Whitehaven Energy proposes 26MW DC, 20MW AC solar farm with a 10MWh battery to connect to the existing 66kV line adjacent to the Narrabri Underground coal mine.

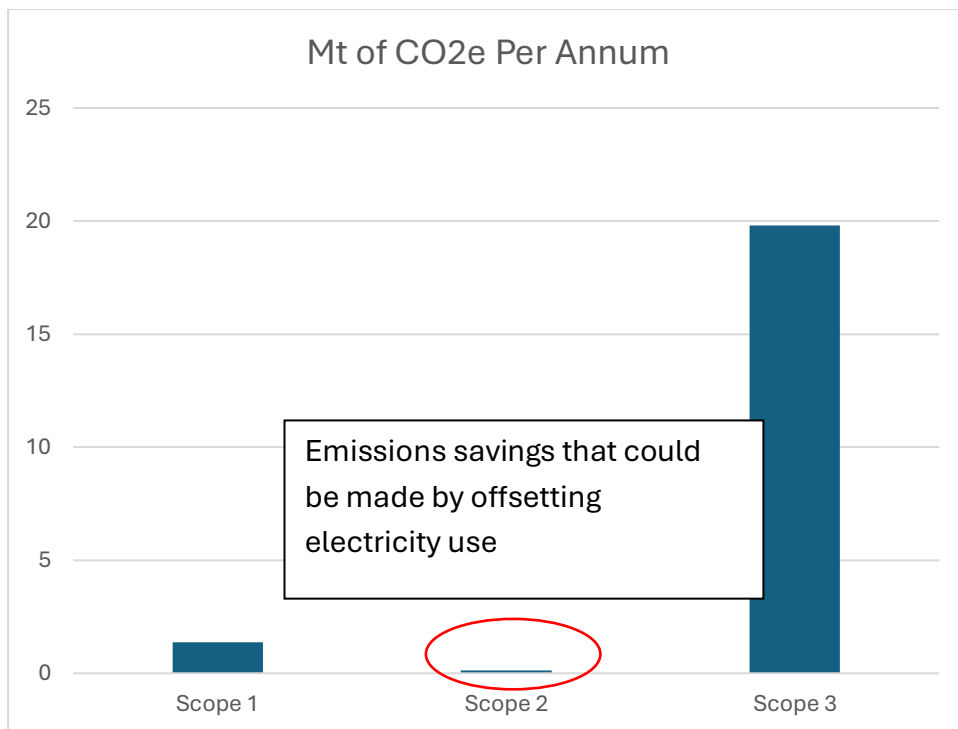
With the information given the emissions savings could be:

- ZERO tonnes p.a of emissions because the current electricity use is already offset by purchasing carbon offsets
- approximately 61,453 t CO<sub>2</sub>-e which is the whole Scope 2 emissions from electricity use at the mine according to the GHG Minimisation Plan for Stage 2
- approx. 150,000tp.a as per the Solar Farm EIS
- Or according to the DPIE's Assessment Report for Stage 3<sup>5</sup> an average 0.12Mt p.a (120,000tp.a).
